DEVELOPMENT REVIEW BOARD REPORT

Miller & Osborn 26-DR-2015

Request approval of the site plan, landscape plan, and building elevations for a new

Stipulations for the

CONCEPTUAL SITE PLAN

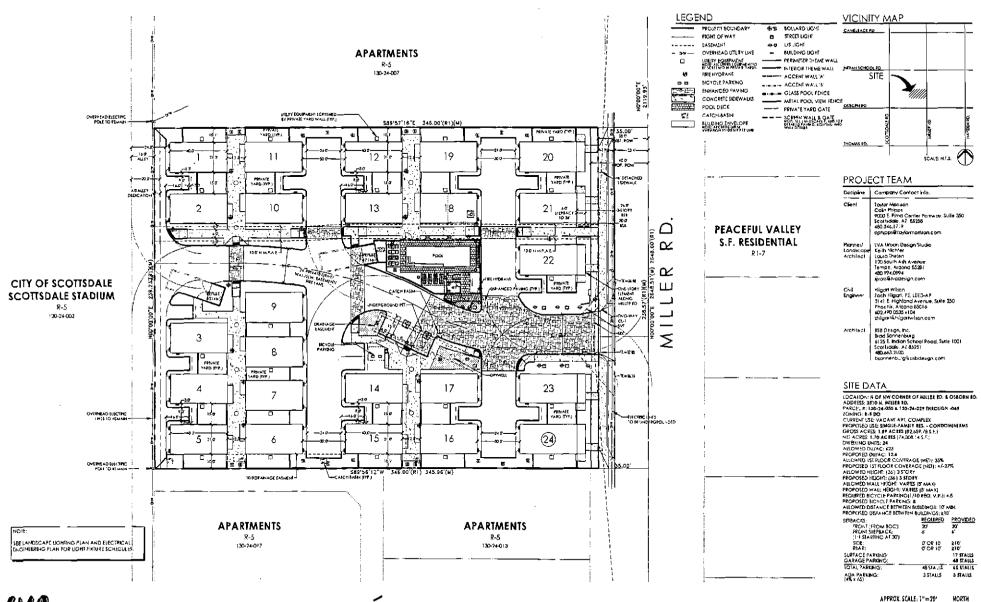
A. All drive aisles that are designated as fire lanes shall have a minimum width of 24 feet. With the final plans submittal, the site plan shall be revised to identify all internal drive aisles as fire lanes.

- 11. Along the public pedestrian path, two additional bollards shall be provided; one near the common area between buildings 13 & 18, and one near the common area between buildings 2 & 10, as identified on the site plan, so that consistent illumination is provided along the entire path.
- 12. All exterior luminaires shall meet all IES requirements for full cutoff, and shall be aimed downward and away from property line except for sign lighting.
- 13. Incorporate the following parking lot and site lighting into the project's design:
